UNIVERSITY OF PENNSYLVANIA BOATHOUSE

RENOVATION & ADDITION TO THE PENN BOATHOUSE

PHILADELPHIA HISTORICAL COMMISSION ARCHITECTURAL COMMITTEE COMMENTS

SUMMARY OF DESIGN REVISIONS

09/14/2020: North Elevation View

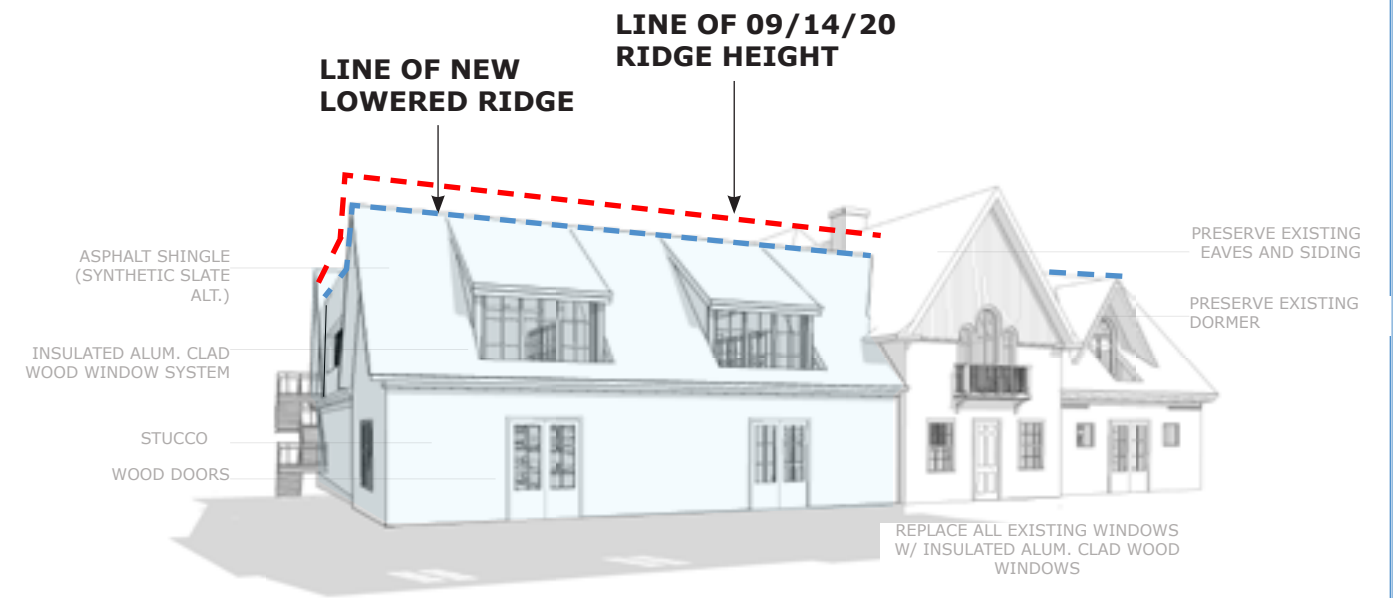
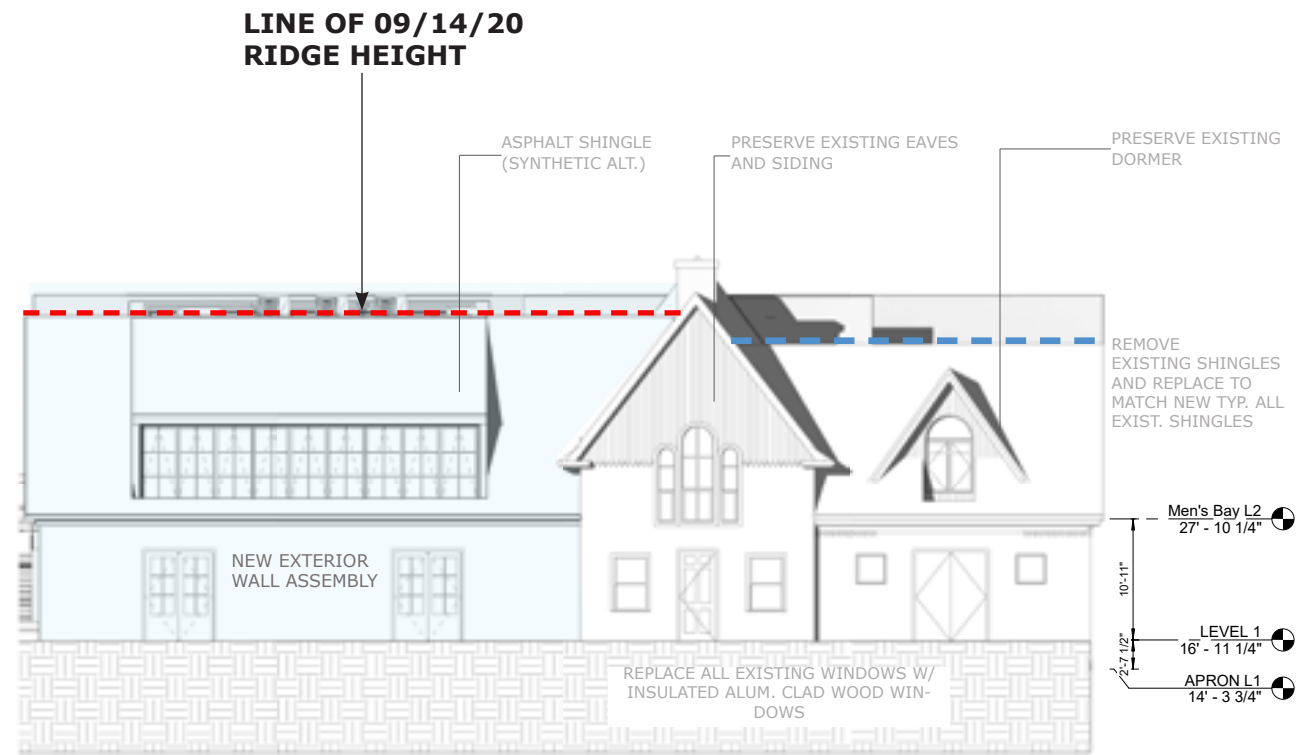
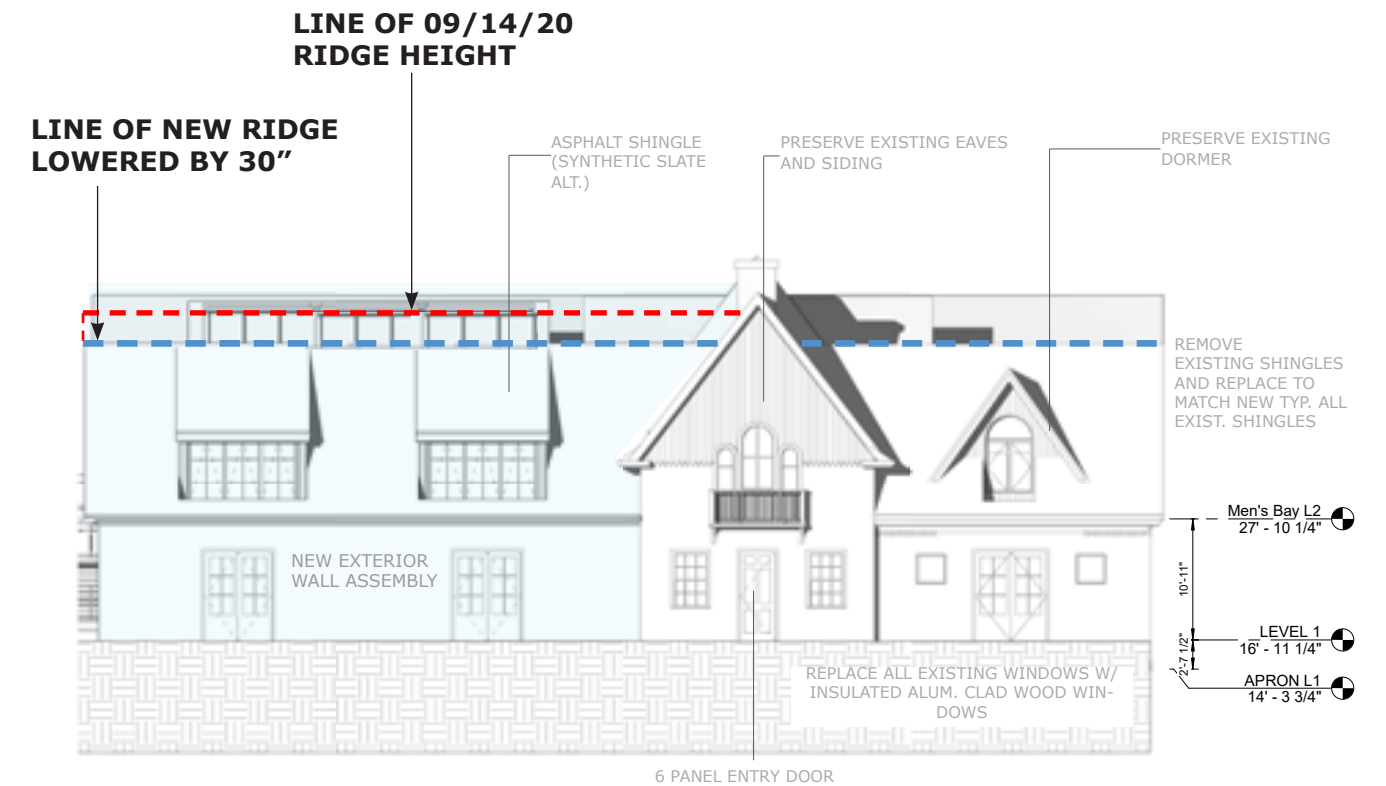
KELLY DRIVE FACADE

Ridge at new addition should be lowered to match existing West Bay ridge

Dormer scale should be reduced and detail should comport with existing shed dormer details

KELLY DRIVE FACADE

Ridge lowered 30" to align with West Bay ridge line

Concealed flat roof (beyond) and roof top equipment lowered 30"

Dormer modified - broke into two separate dormers

Reduced elevation of eave

Modified detail to reference existing shed dormers

Restored main entry pavilion with historic balcony and original window and door configuration

09/14/2020: South Elevation View

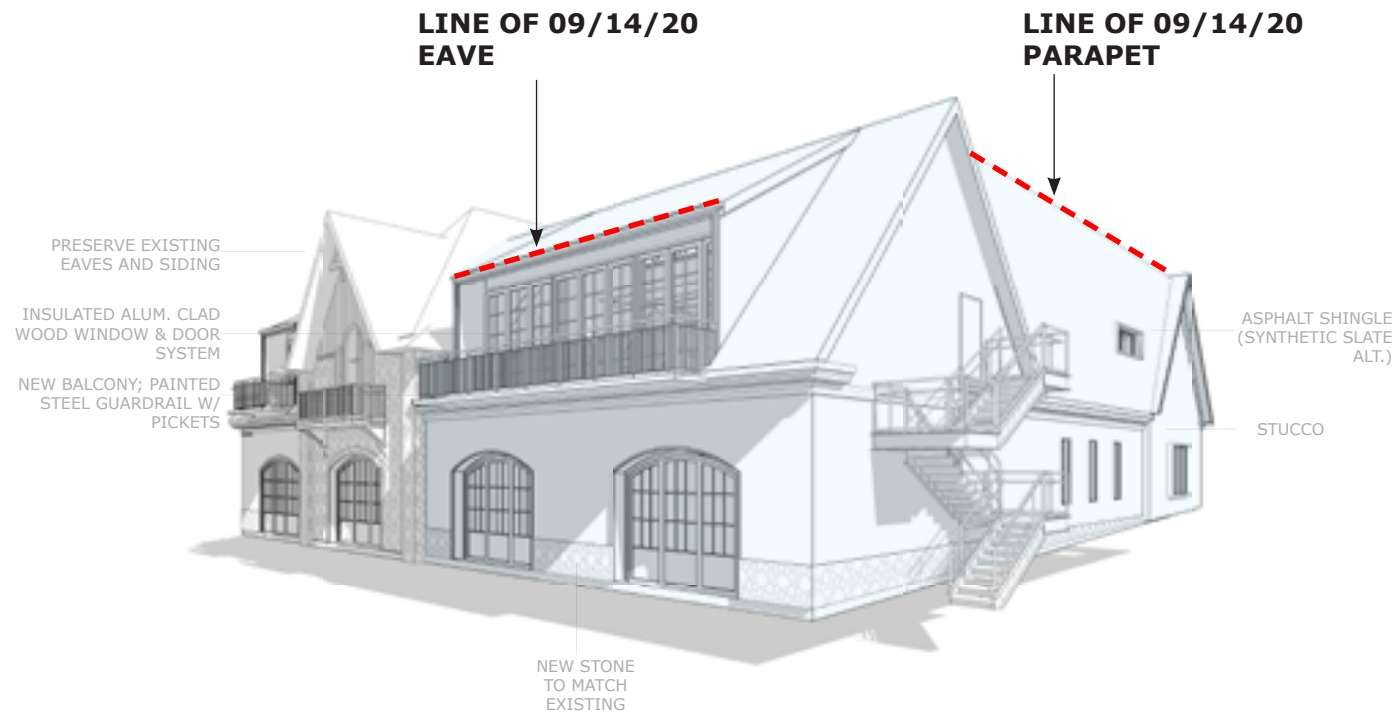
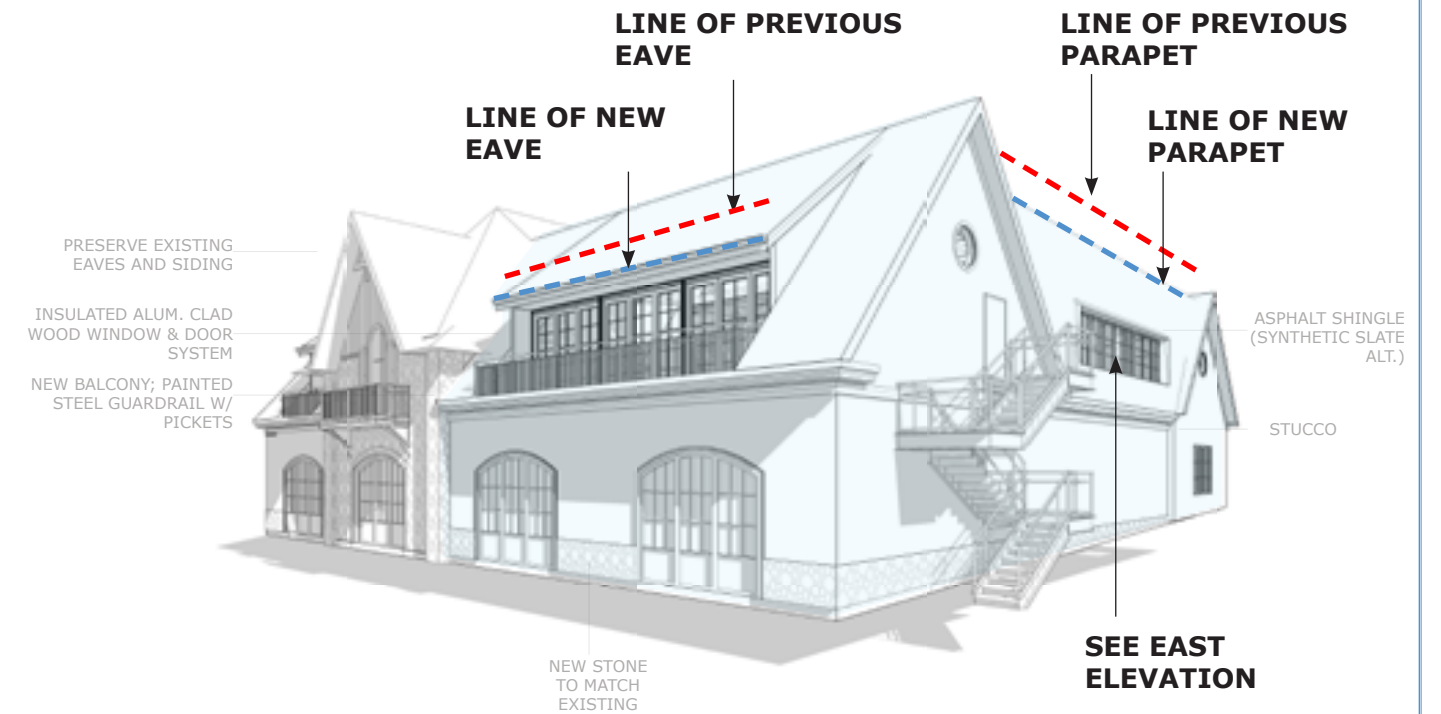
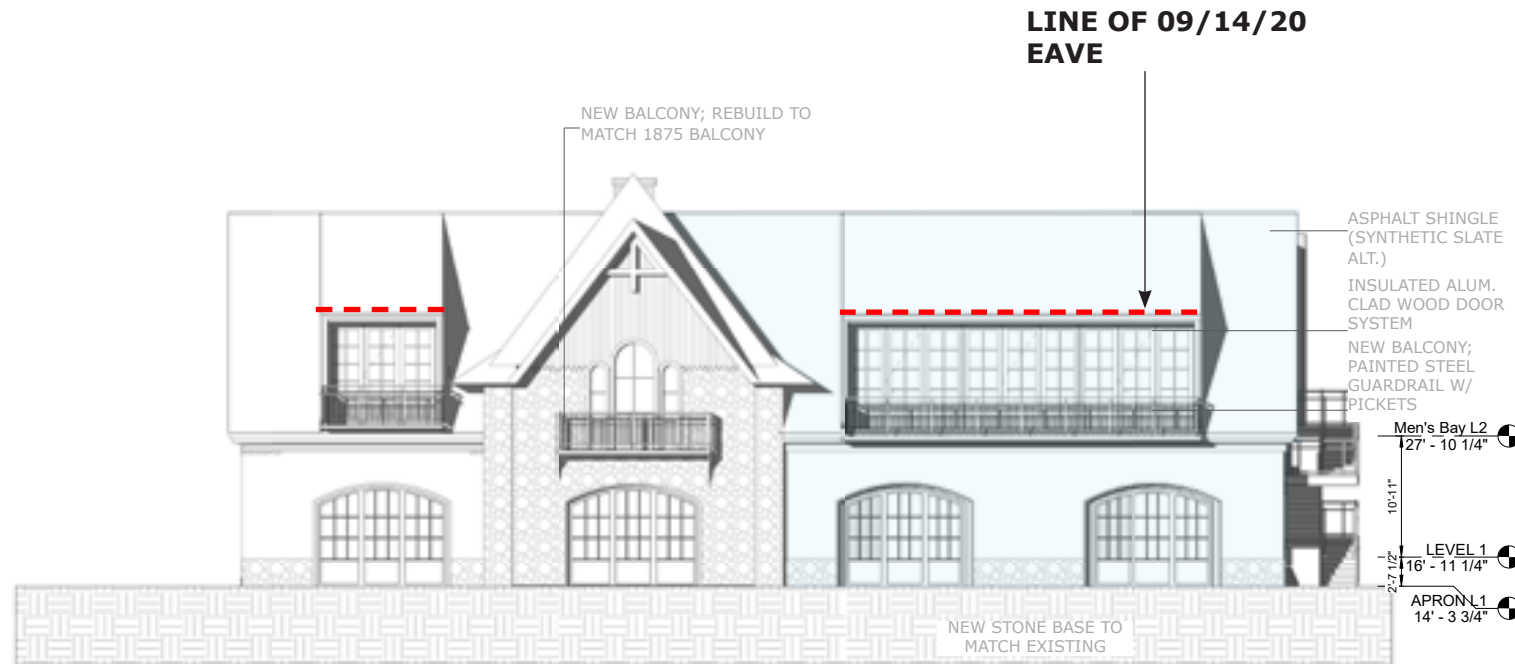
SCHUYLKILL FACADE

Dormers overwhelm the facade - they should be reduced in scale and character should reference existing shed dormer details

New East & West Bay balconies overwhelm facade

SCHUYLKILL FACADE

Dormers modified

Reduced height of dormers and glazing by 24" to match existing West Bay dormer height

Modified detailing to reflect existing shed dormer details & materials

Modified balconies

Reduced projection and scale of balcony elements to be within cornice and wall below

Modified details to be more contextual

09/14/2020 East Elevation View

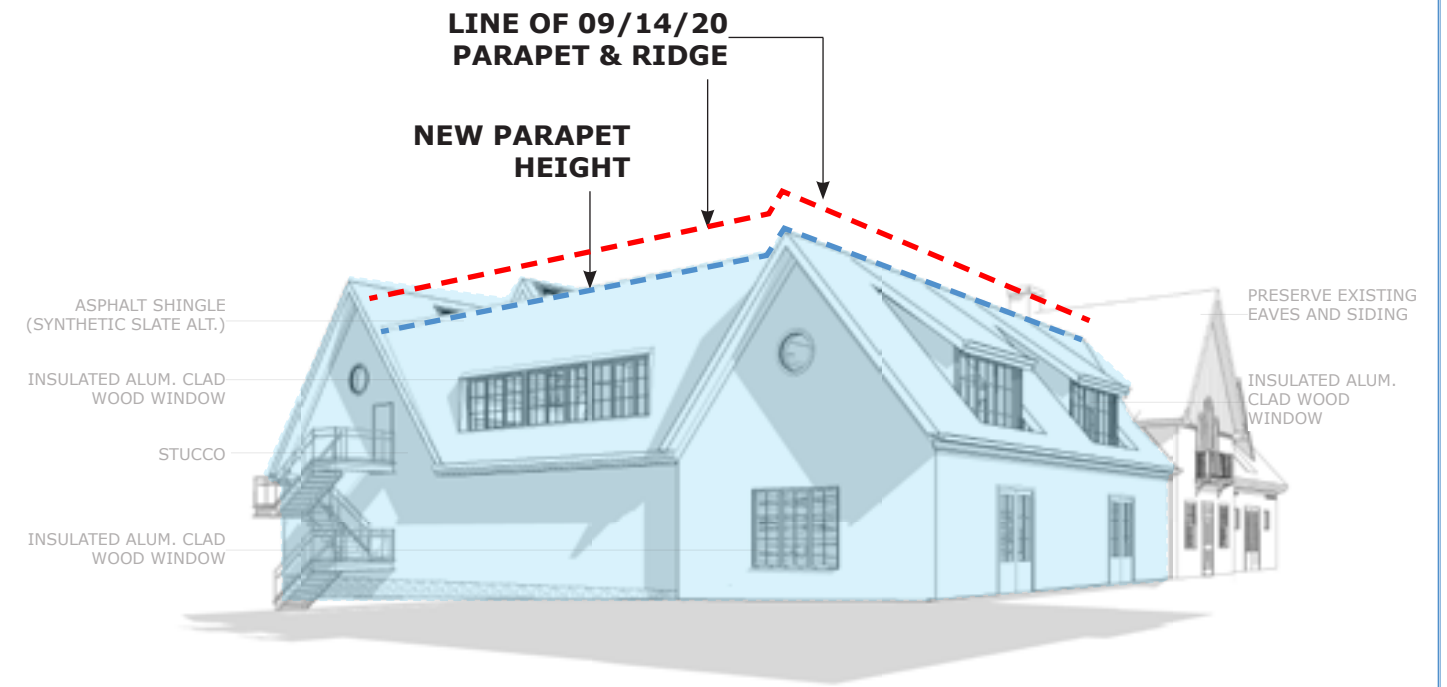
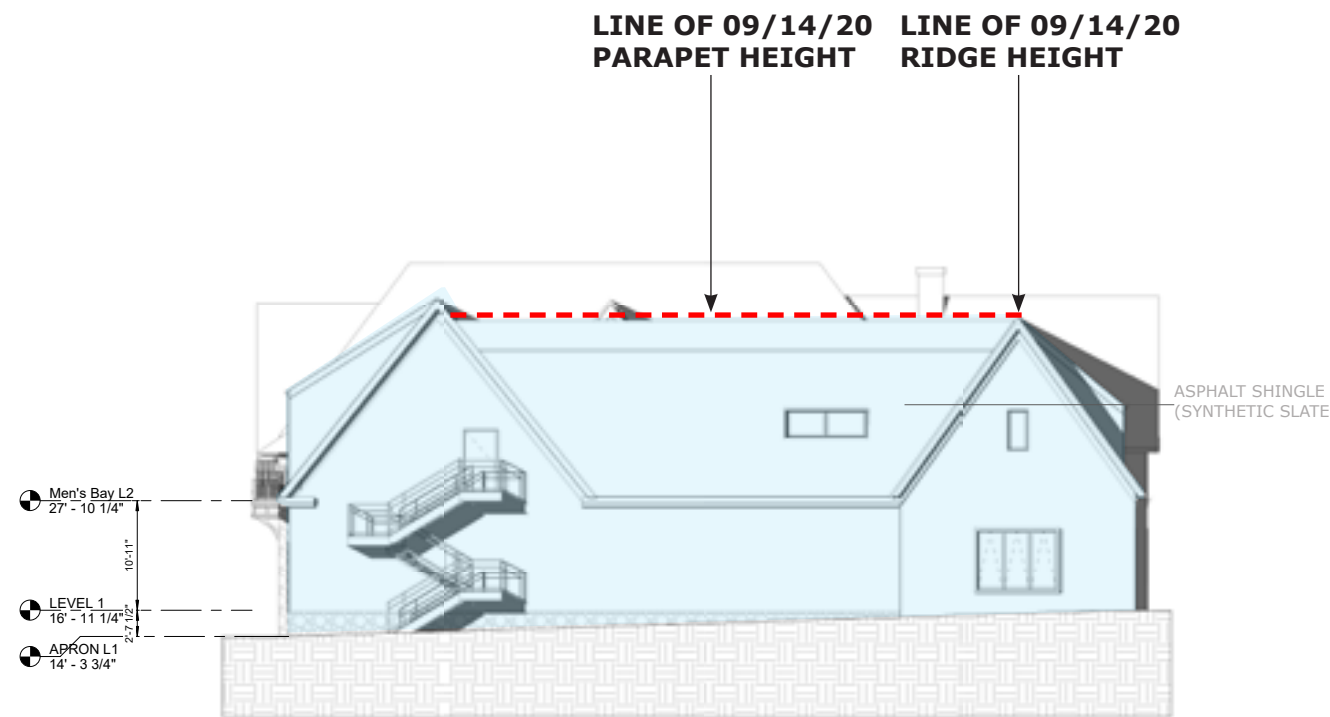
EAST FACADE

Facade scale is too large and undifferentiated (looks like a "billboard")

Facade should reference existing facade - reduce scale, incorporate glazing

EAST FACADE

Reduced parapet height by 36" and north gable end by 30"

Incorporated fenestration consistent with existing, including rounds and double-hungs

SIGHTLINE STUDIES

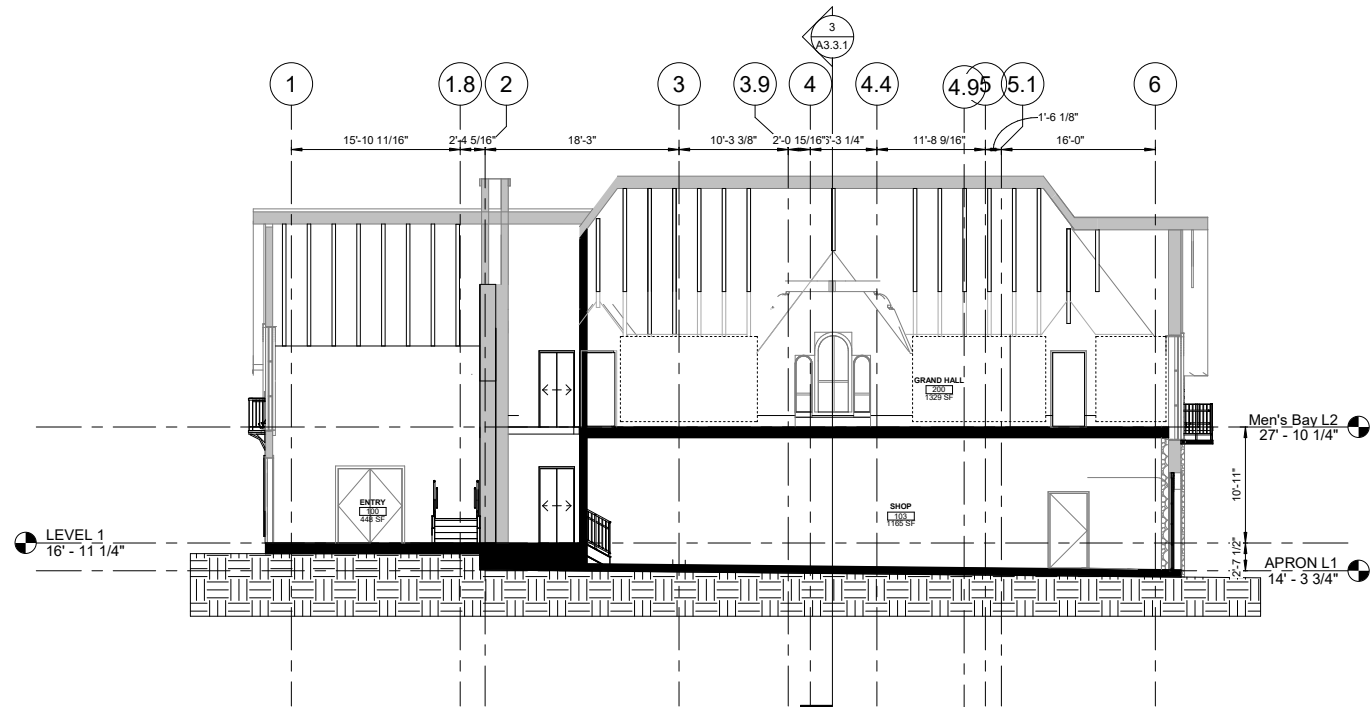
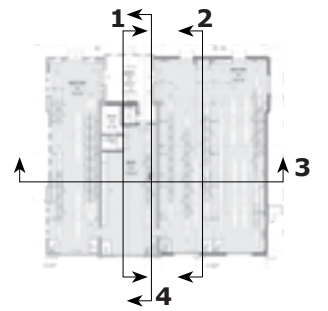
The view to the left shows the current visibility of the East Facade with boat racks adjacent to the facade. The images below, show the previous design with higher ridge line and steeper slopes on the left, and on the right a revised design showing reduced slopes and lowered ridge.

The revised design consists of a lowered ridge line of the Kelly Drive facade by 30", and lowered parapet of the East Elevation by 36". In order to reduce equipment visibility, the roof area hosting the equipment was also lowered by 30".
